PEACH BOTTOM ATOMIC POWER STATION, UNIT NO. 3

AMENDMENT TO FACILITY OPERATING LICENSE

Amendment No. 33
License No. DPR-56

ATTACHMENT TO LICENSE AMENDMENT NO. 33

Figure 3.5.1.F Maximum Average Planar Linear Heat Generation Rate Versus Planar Average Exposure

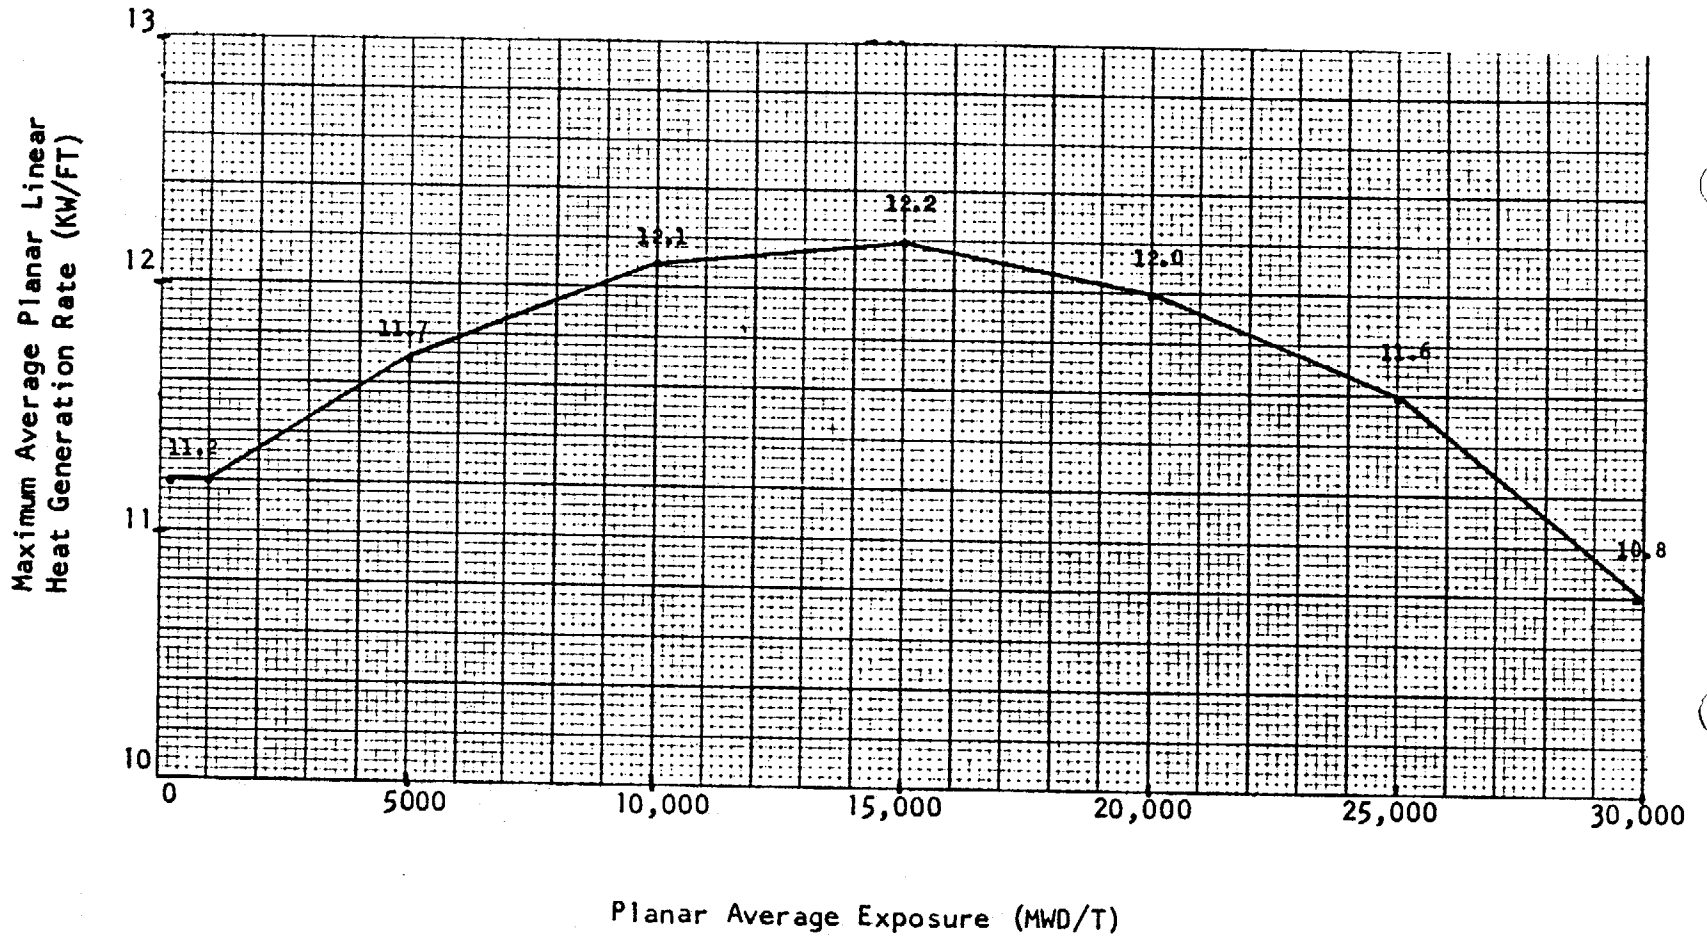
The loss-of-coolant accident was reanalyzed for the Reload 1 8x8 fuel with 100 mil channels and also for the PTA, with the results presented in References 1 and 2. The analysis indicated compliance with the Section 50.46 criteria and Appendix K to 10 CFR Part 50. The submitted Technical Specification changes (4) included new MAPLHGR curves for the 8x8 fuel (Figure 3.5.1F) and the PTA (Figure 3.5.1G).

During power operation, the APLHGR for each type of fuel as a function of average planar exposure shall not exceed the limiting value shown in Figure 3.5.1-A, 3.5.1-B, 3.5.1-C, 3.5.1-D, as applicable. If at any time during operation it is determined by normal surveillance that the limiting value of APLHGR is being exceeded, action shall be initiated within one (1) hour to restore APLHGR to within prescribed limits. If the APLHGR is not returned to within prescribed limits within five (5) hours, reactor power shall be decreased at a rate which would bring the reactor to the cold shutdown condition within 36 hours unless APLHGR is returned to within limits during this period. Surveillance and corresponding action shall continue until reactor operation is within the prescribed limits.
